Customer Communication N°: 1
Date : 03-Aug-26

Object: APTIV external communication about Product End Of Lifetime

Due to DCS2 2.8 capacity extension the replacement parts change their part numbers. Also crimping procession changes:
(You can find a more detailed description on the next page)

■ Layout contact body/ hood

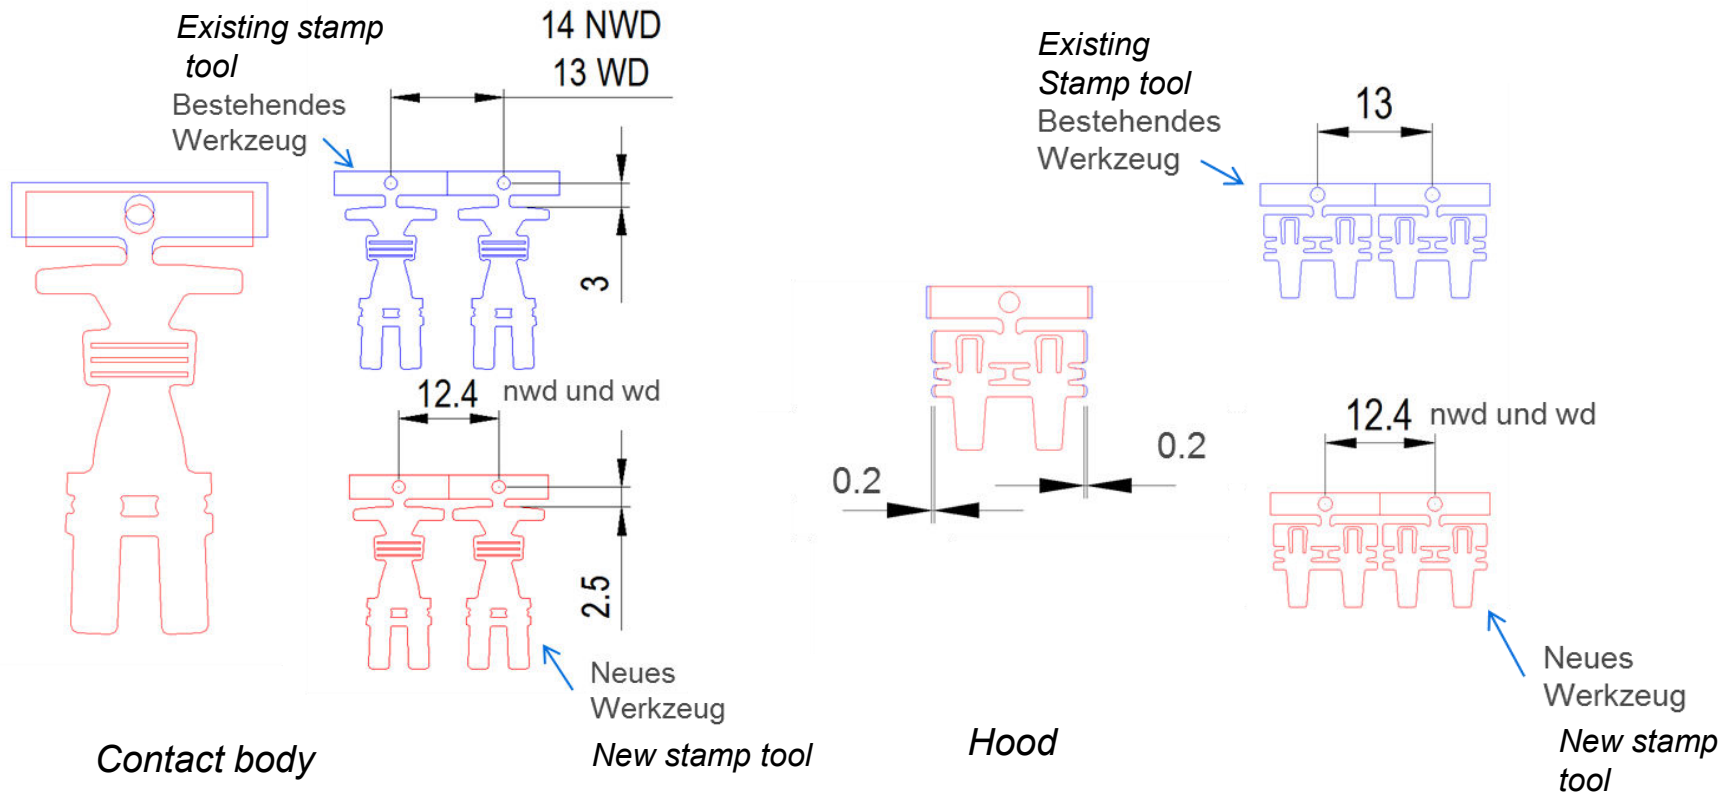
◆ Comparison stamp tool 1-out die to 2-out

◆ Crimp Applicator

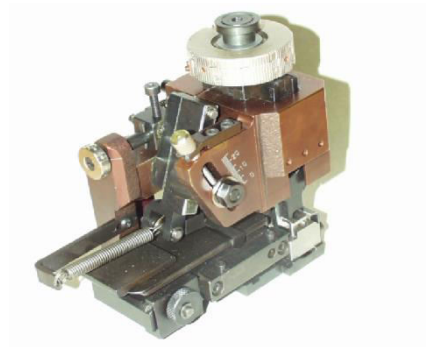
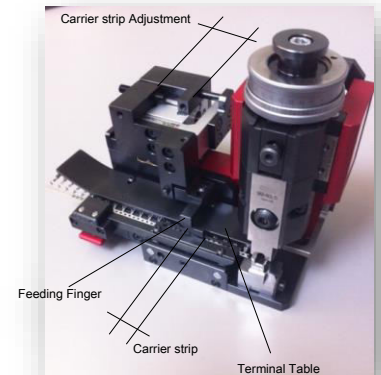
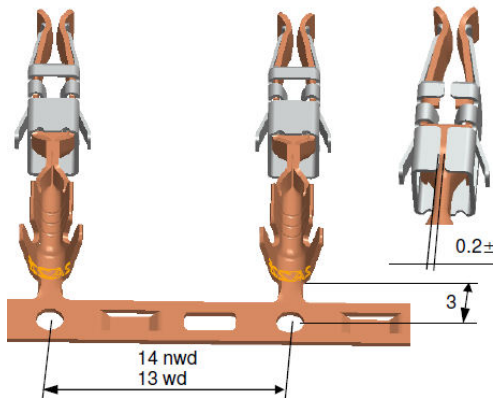
- New crimp applicator numbers: 6 520 04 09 / 39 / 47 / 48
- Spare parts identically
- The existing crimp applicators are adjustable according to new part dimensions
 - Progression change
 - Distance pilot hole to end of insulation crimp
 - 1 hour/ tool
- New crimp applicators
 - No adjustment necessary

DCS-2 2,8 (old)

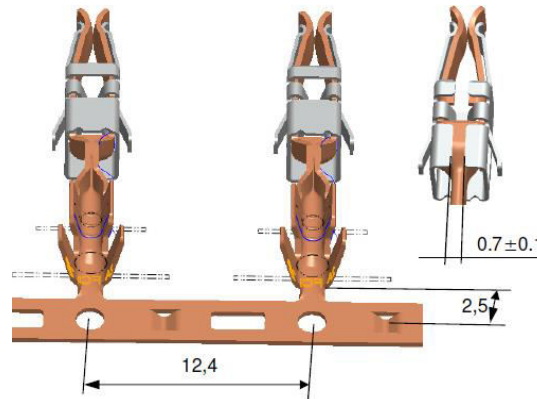
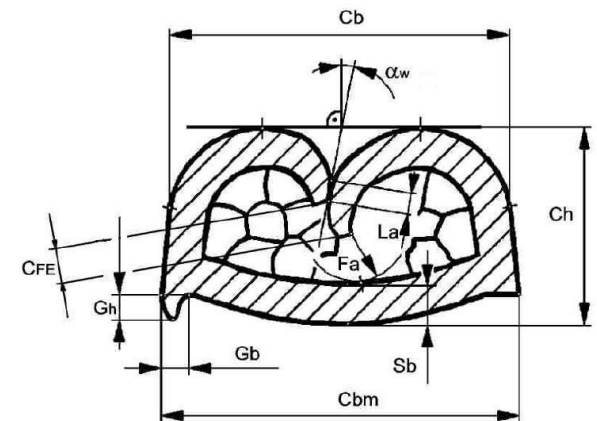
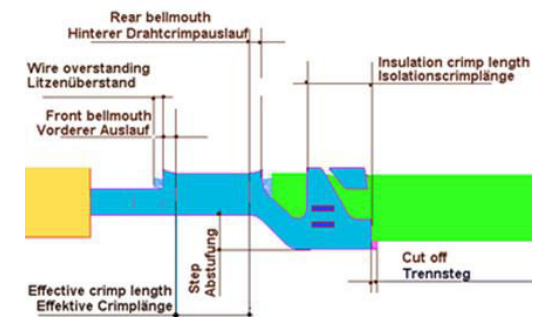
Adjust symmetry and cut off

No spare part modification necessary.
New applicator not necessary only adjustment.
